## DEVIATION REQUEST AND DECISION FORM

Project Name : **BENT GRASS EAST COMMERCIAL FILING NO. 3**  
Schedule No.(s) : 53011-01-060  
Legal Description : Tract BB, Bent Grass East Commercial Filing No. 2B

A deviation from the standards of or in Section **2.2.4.B.6 and 2.5.2.B.3** of the Engineering Criteria Manual (ECM) is requested.

BENT GRASS EAST  
COMMERCIAL FILING NO. 3  
PEDESTRIAN ACCESS EXHIBIT

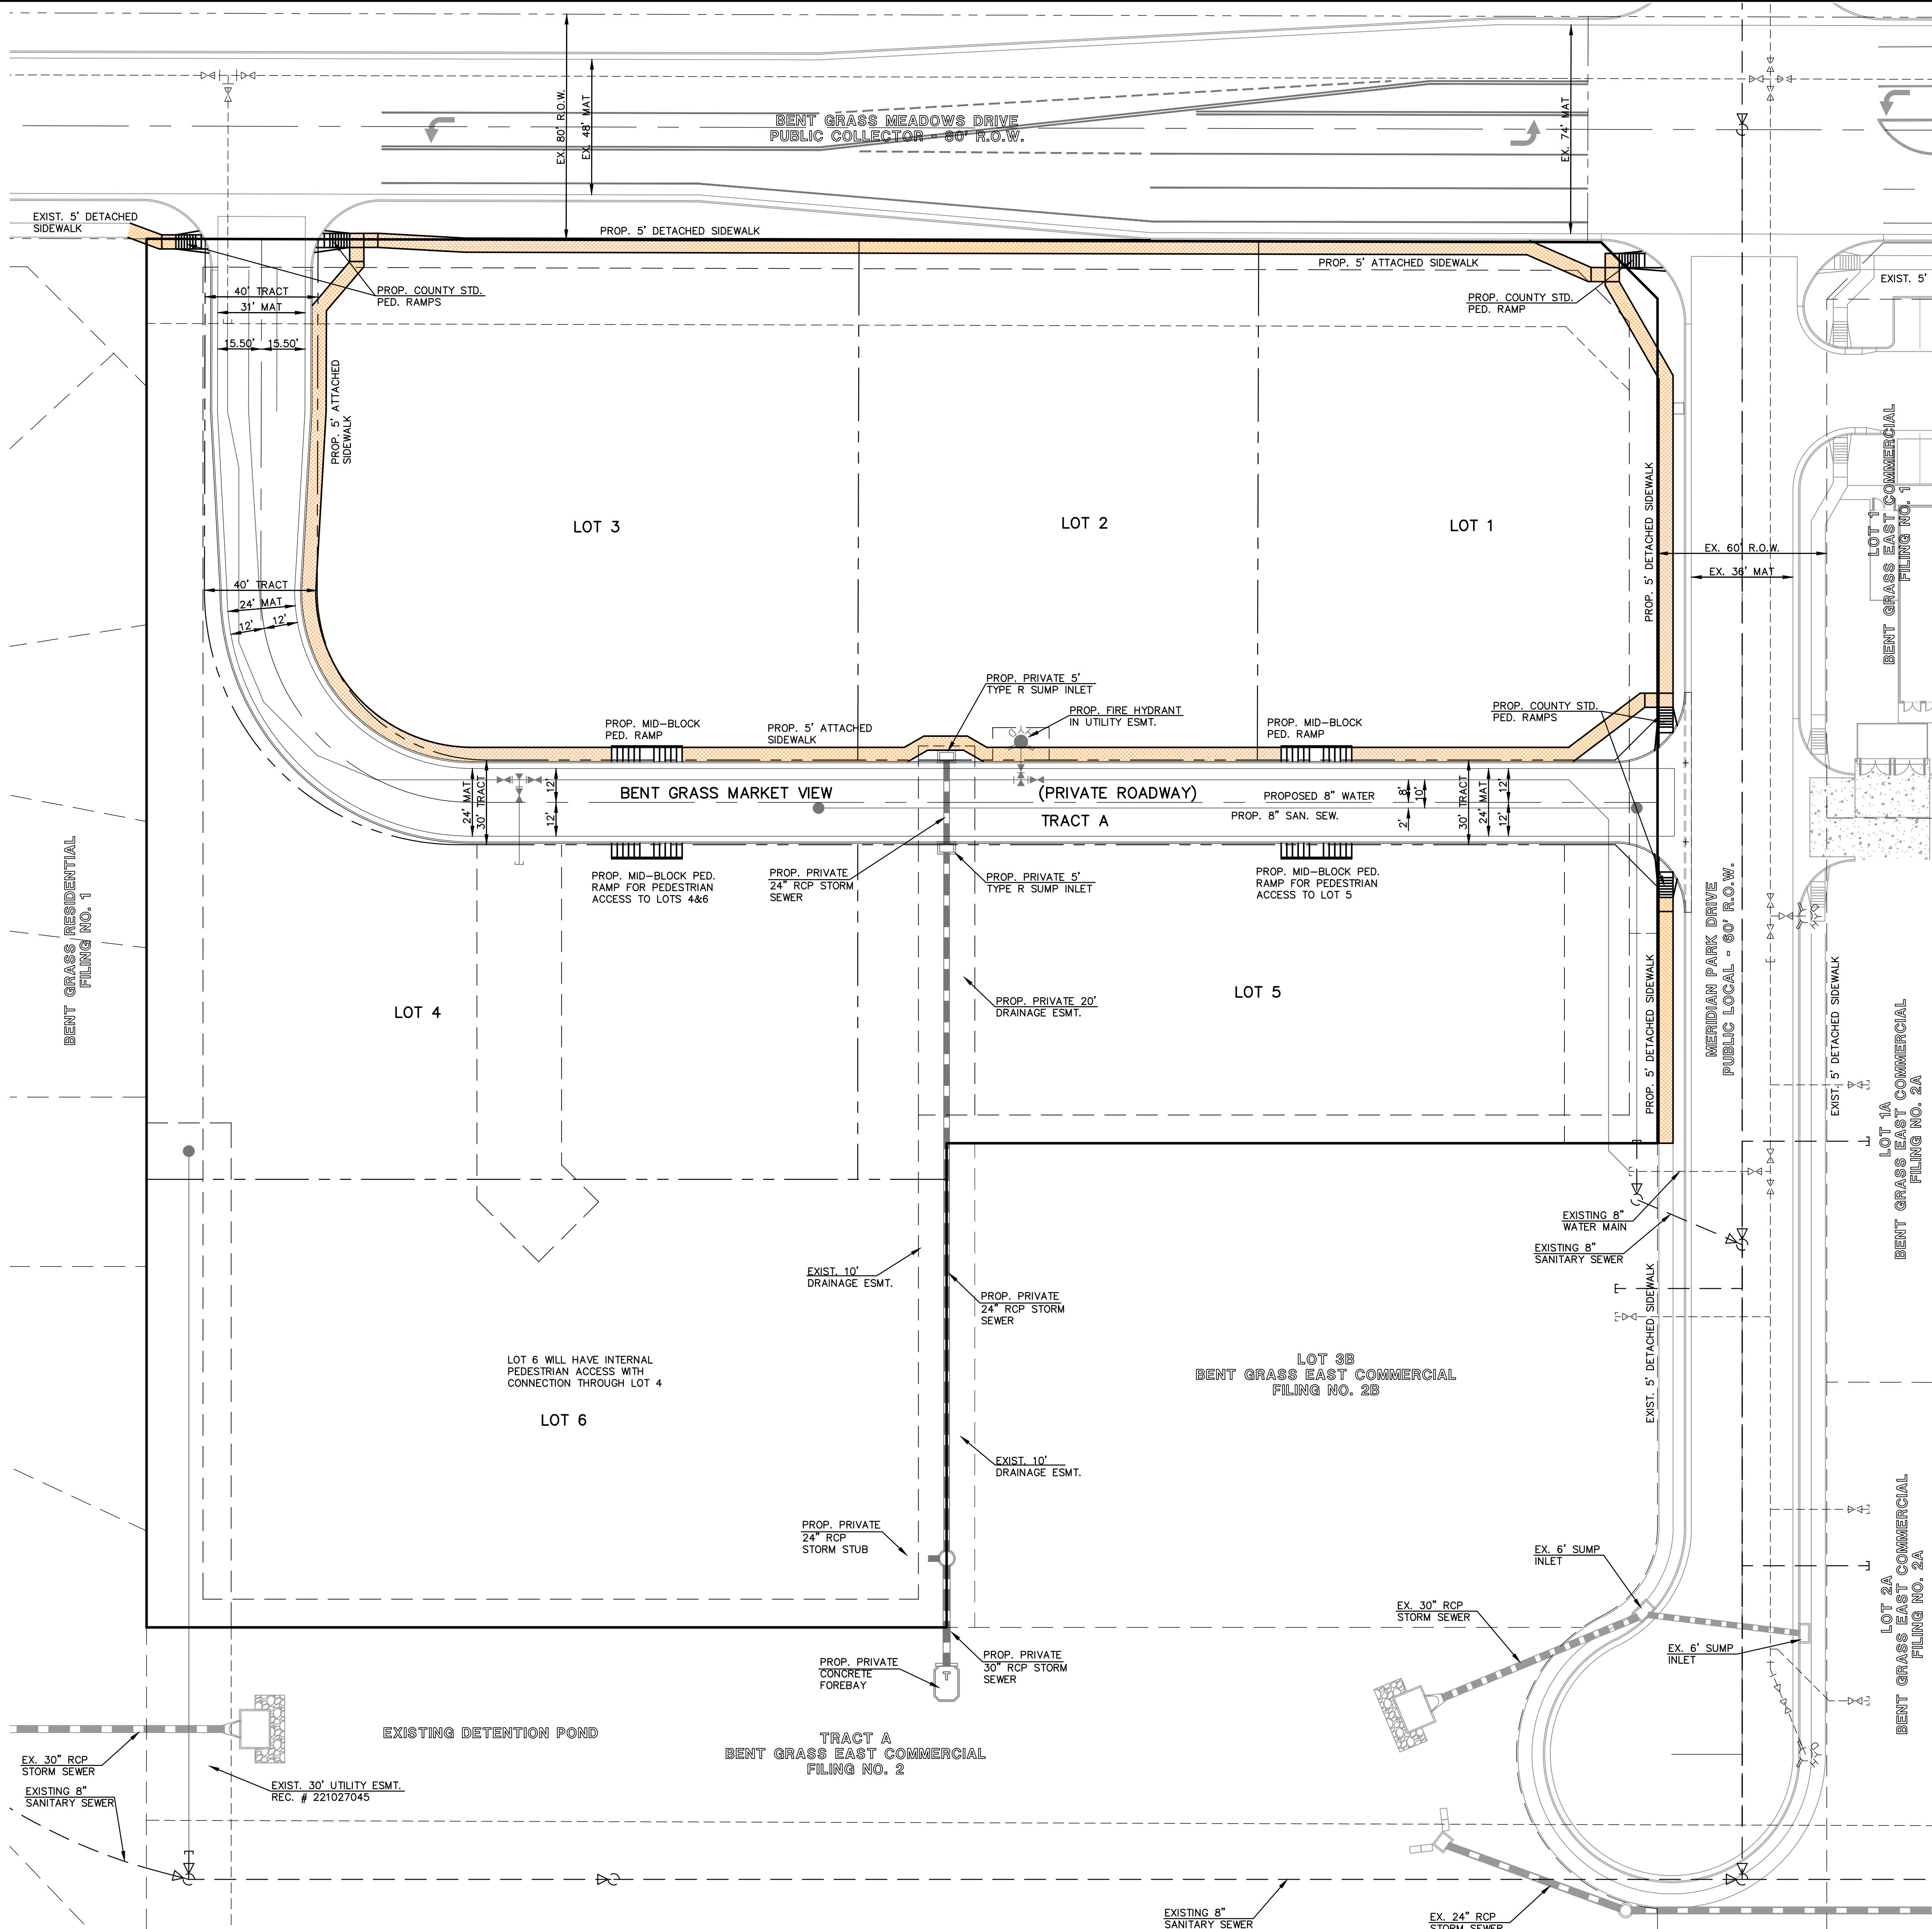
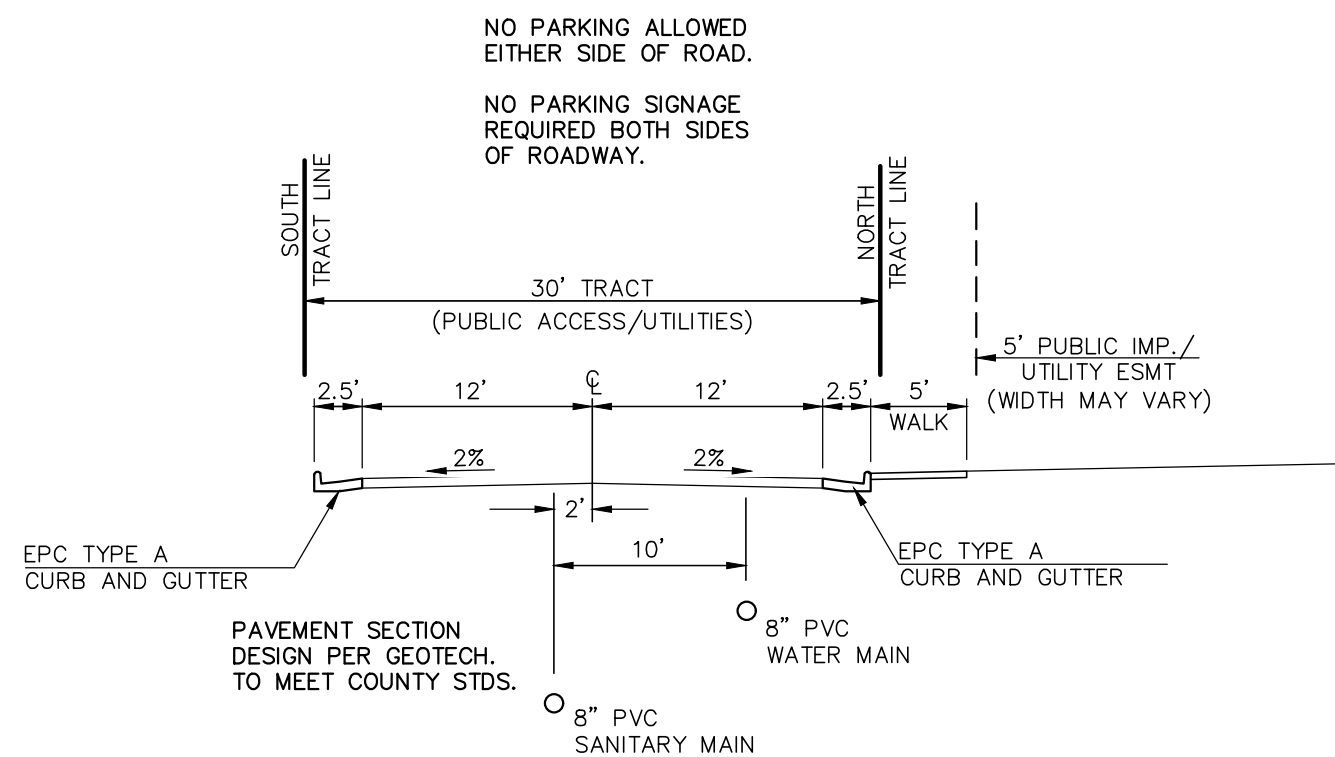
Paved width proposed is 24' compared to 30' for Local and 24' for Local low-volume.

Sidewalk (5.0' attached) is proposed along one side of the private roadway only with two mid-block pedestrian ramp crossings compared to both sides for Local.

TRUCK TURNING EXHIBIT  
(WB-40 INT. SEMI-TRAILER)

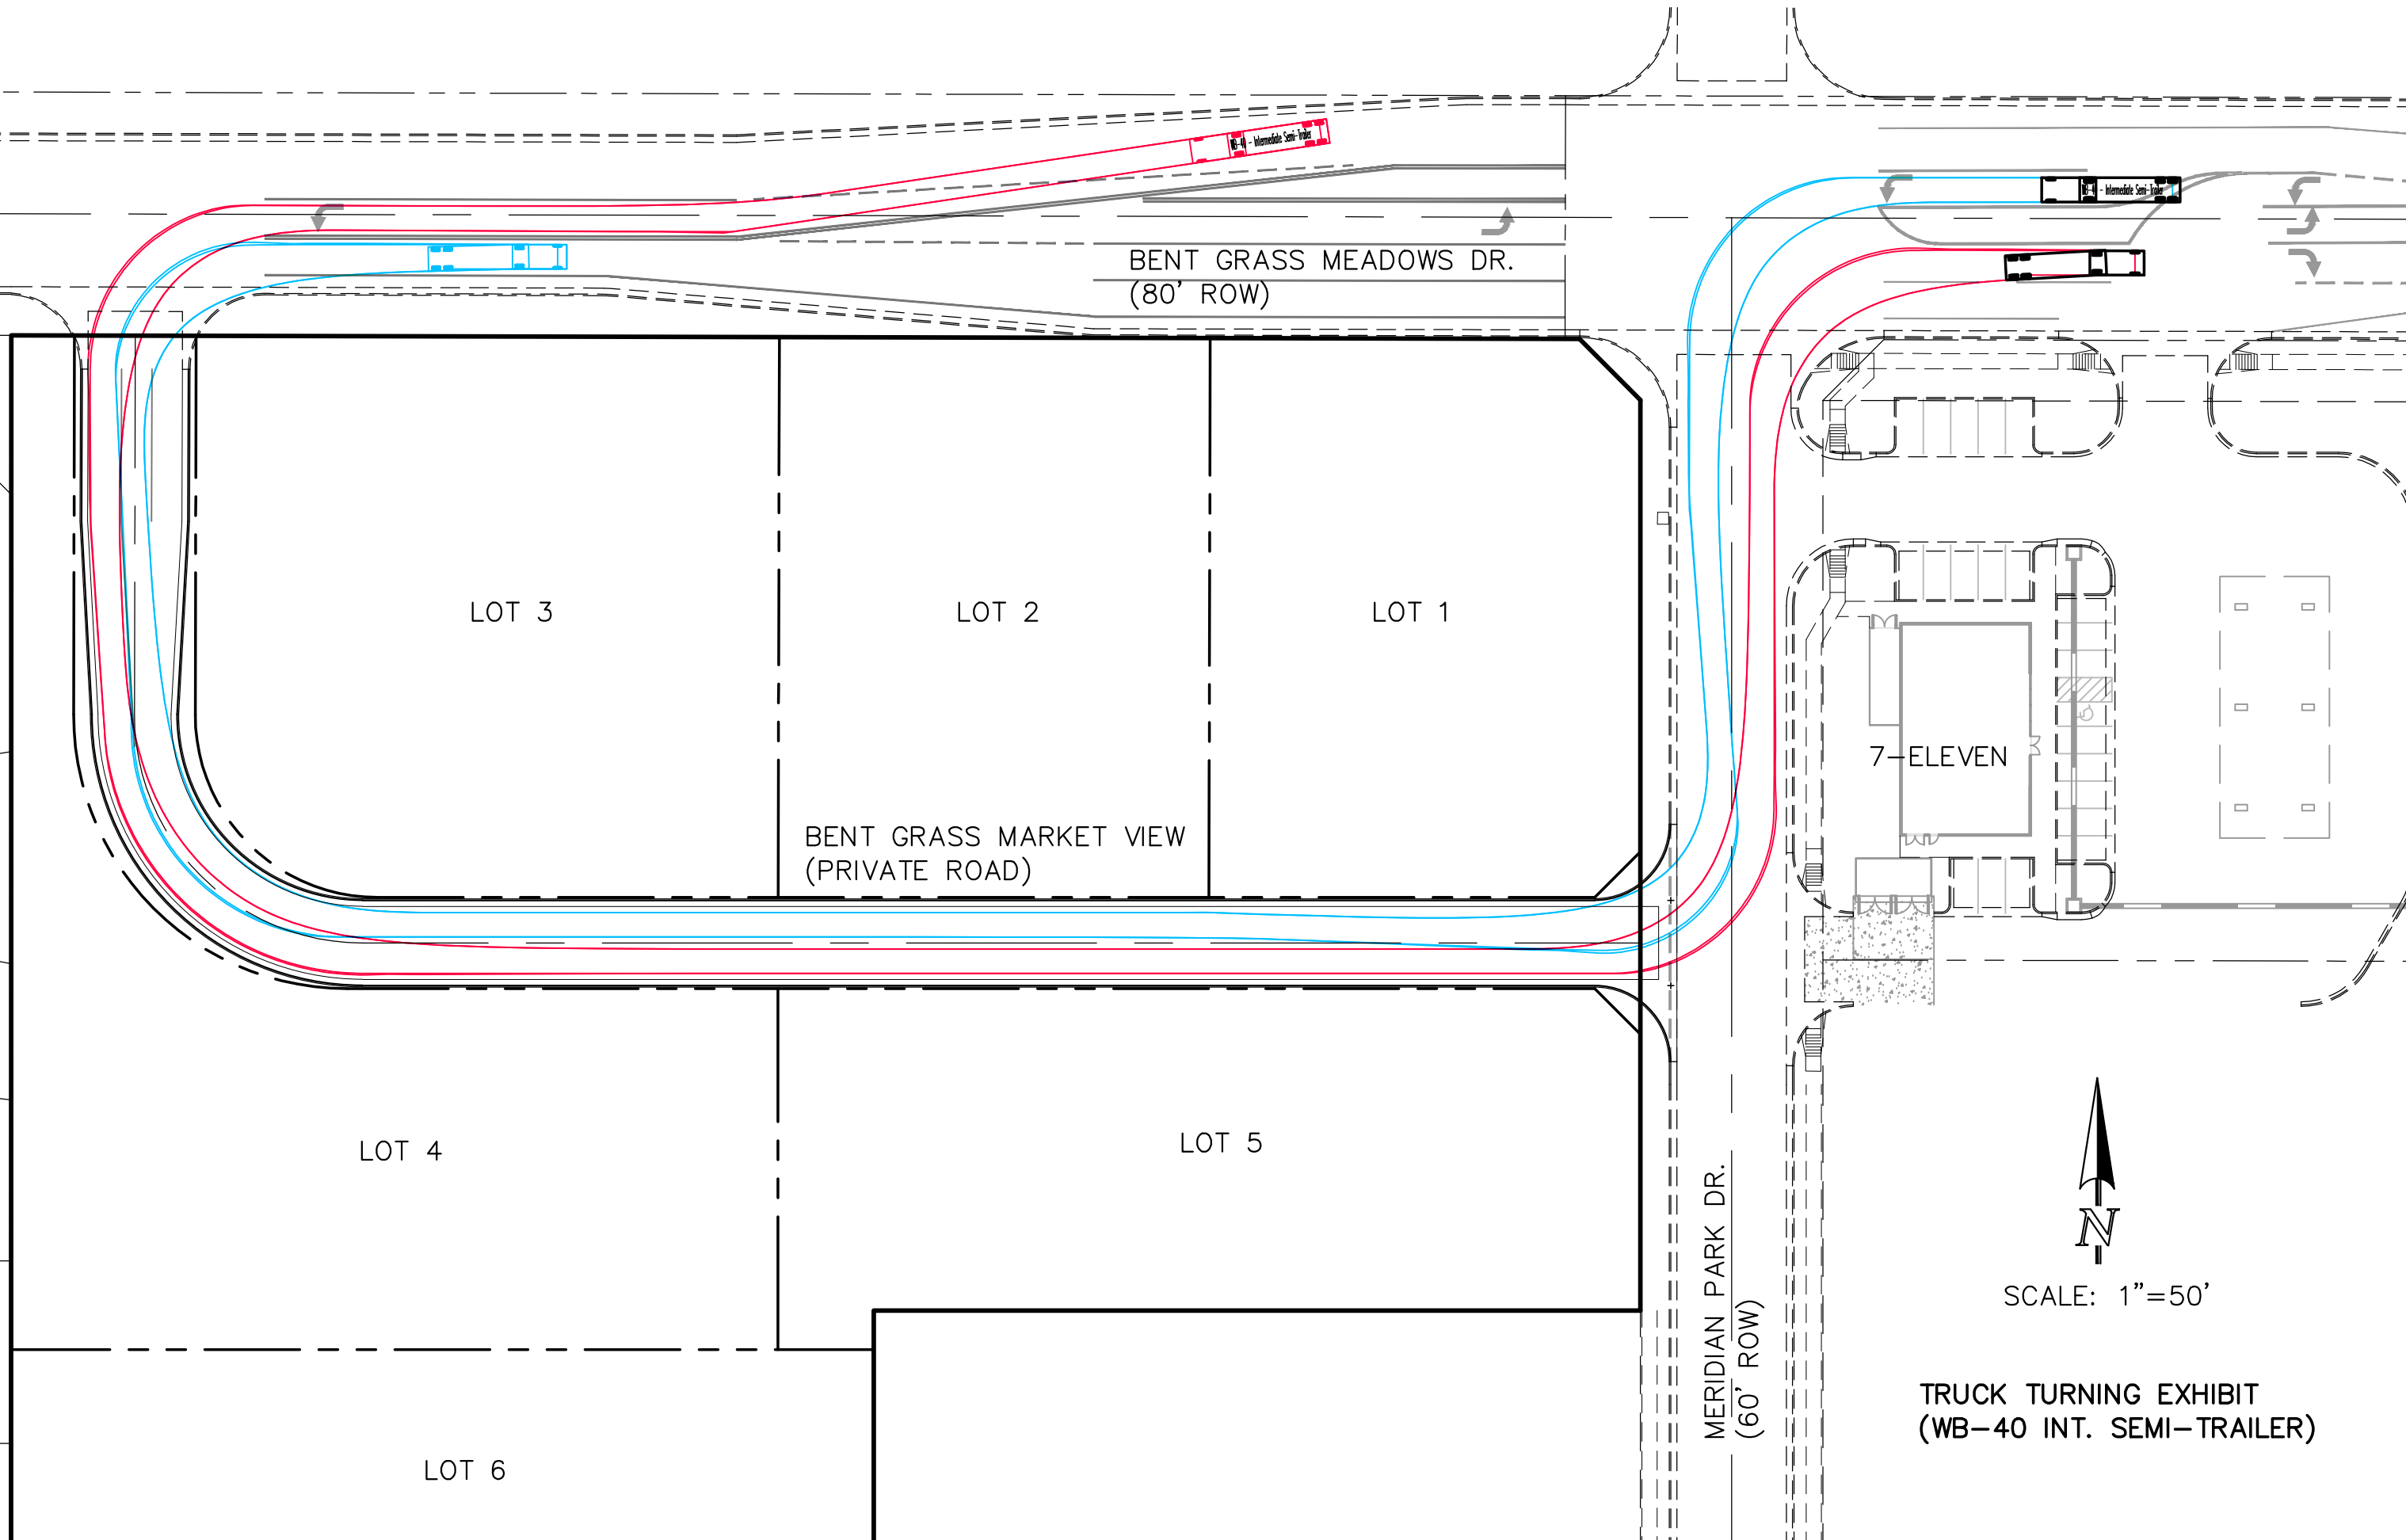
Min. CL curve Radius proposed is 75' compared to the 200' for Local and 100' for Local low-volume. (Reference attached truck turning exhibit showing adequate site access)
